5. COA-047305-2019

2109 Cedar Street

Commission of Architectural Review

STAFF REPORT

Figure 3. 1905 Sanborn Map

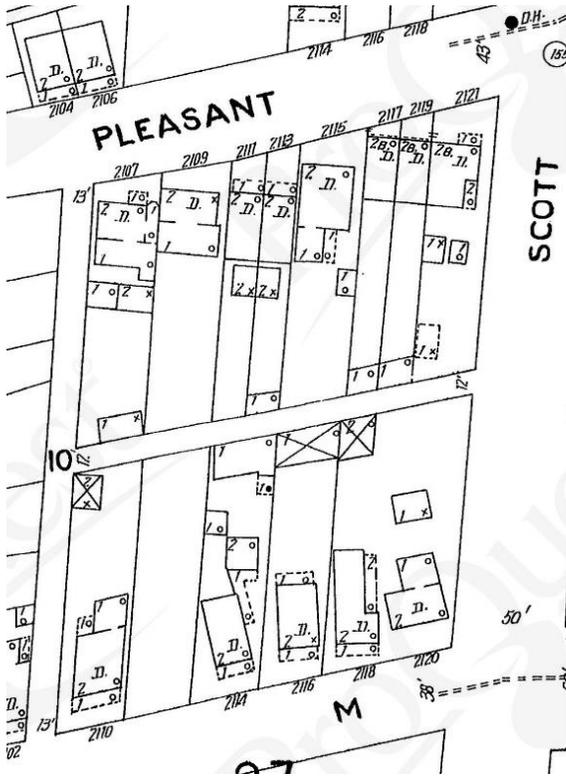
| Pg. 51, Residential Outbuildings #2 | <i>Newly constructed outbuildings such as detached garages or tool sheds should respect the siting, massing, roof profiles, materials and colors of existing outbuildings.</i> | There are few outbuildings on the subject block, however Sanborn maps indicate that one- and two-story outbuildings were historically located on the block. |
